**Subject:** RE: <EXTERNAL> EB-2021-0117 DSC Response to Extension for Written Comments (1 of 2 LDS and EB-2021-0117/EB-2019-0207)

From the Dec 20<sup>th</sup> Notice of Revised Proposal to Amend the Distribution System Code:

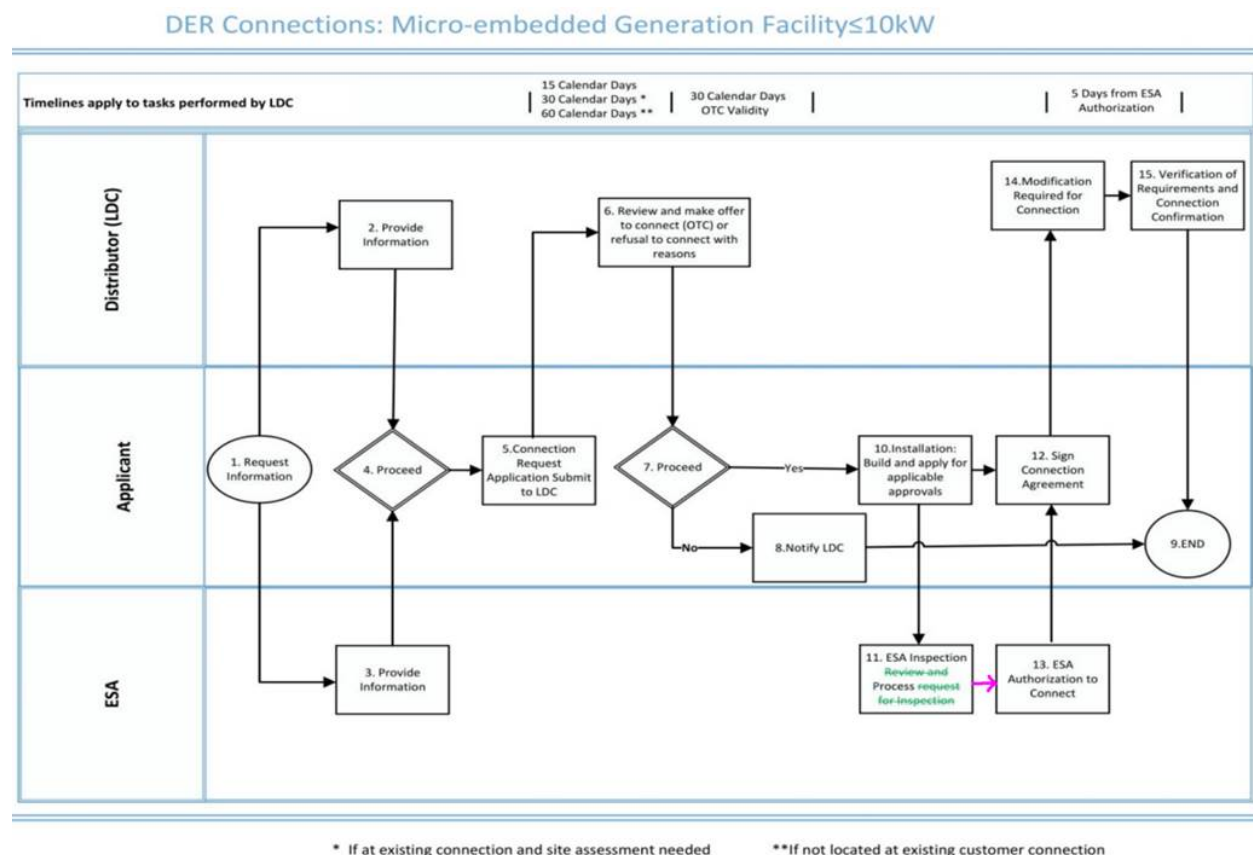
The only suggested change from ESA should be to add the arrow between Step 11 and Step 13, as shown below.

\* If at existing connection and site assessment needed

\*\*If not located at existing customer connection
